Work Order ID 99250

Item Name: Crosstube Aft

DRAWING NO. D412-664-243	TITLE CROSSTUBE ASS'Y (412 HI AFT)	REV. E	DART AEROSPACE LTD ENGINEERING ORDER		D.E.O. NO. D412-664-243-E-2	SHEET NO. SHEET 1 OF 1	SCALE NTS
DRAWN <i>MP</i>	CHECKED <i>ASS</i>	MFG. APPR. <i>RE</i>	APPROVED <i>MP</i>		DE APPR. <i>MP</i>		
DATE 11.09.07	DATE 11.09.19	DATE 11.09.19	DATE 11.09.19		DATE 11.09.19

DRAWING NO. D412-664-243	TITLE CROSSTUBE ASSEMBLY (412 HI AFT)	REV. E	DART AEROSPACE LTD ENGINEERING ORDER		D.E.O. NO. D412-664-243-E-4	SHEET NO. SHEET 1 OF 3	SCALE NTS
DRAWN JP	CHECKED A	MFG. APPR. A	APPROVED MP		DE APPR. MP		
DATE 12.08.21	DATE 12.08.30	DATE 12.08.30	DATE 12/8/30		DATE 12.08.30

**D412-664-243
ASSEMBLY DETAIL**

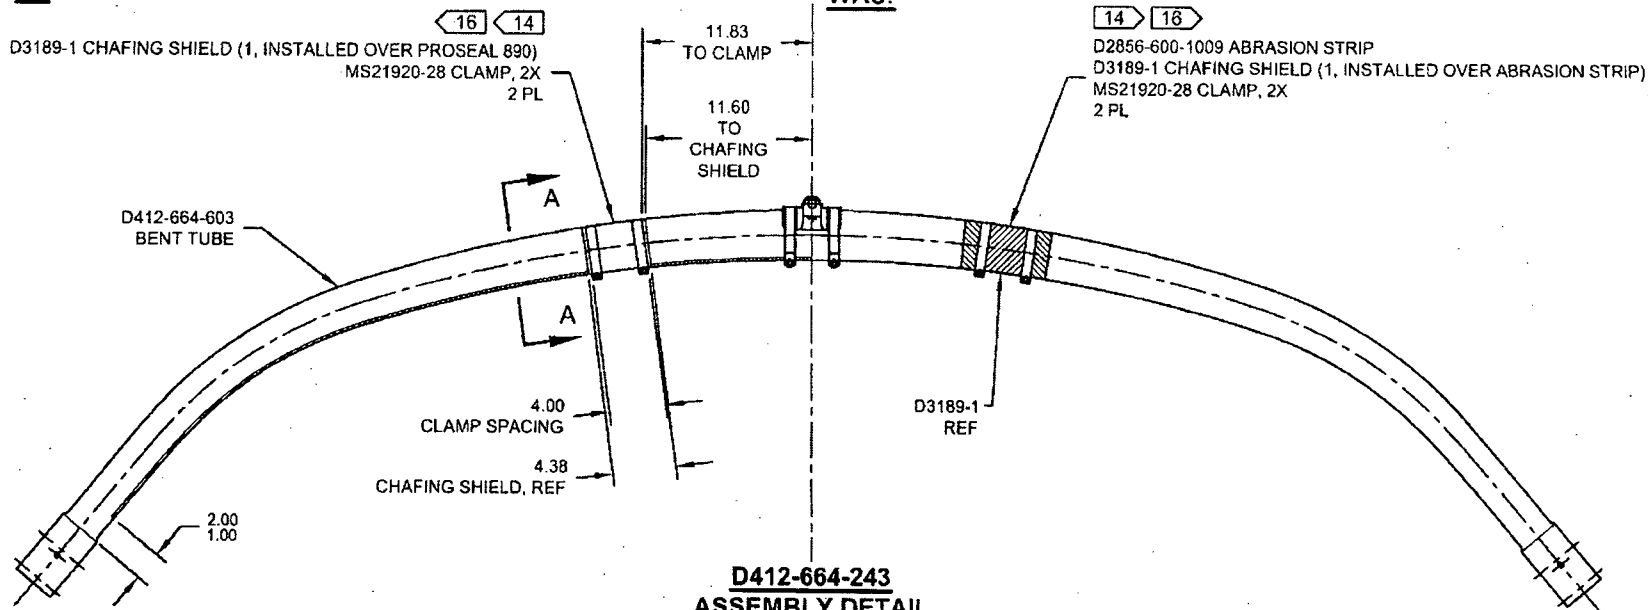
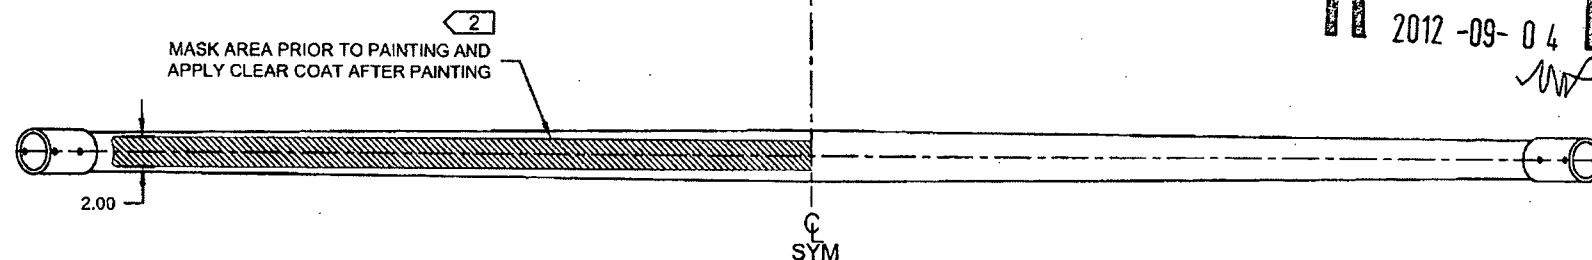
IS:

D3189-1 CHAFING SHIELD (1, INSTALLED OVER PROSEAL 890)
MS21920-28 CLAMP, 2X
2 PL

WAS:

D2856-600-1009 ABRASION STRIP
D3189-1 CHAFING SHIELD (1, INSTALLED OVER ABRASION STRIP)
MS21920-28 CLAMP, 2X
2 PL
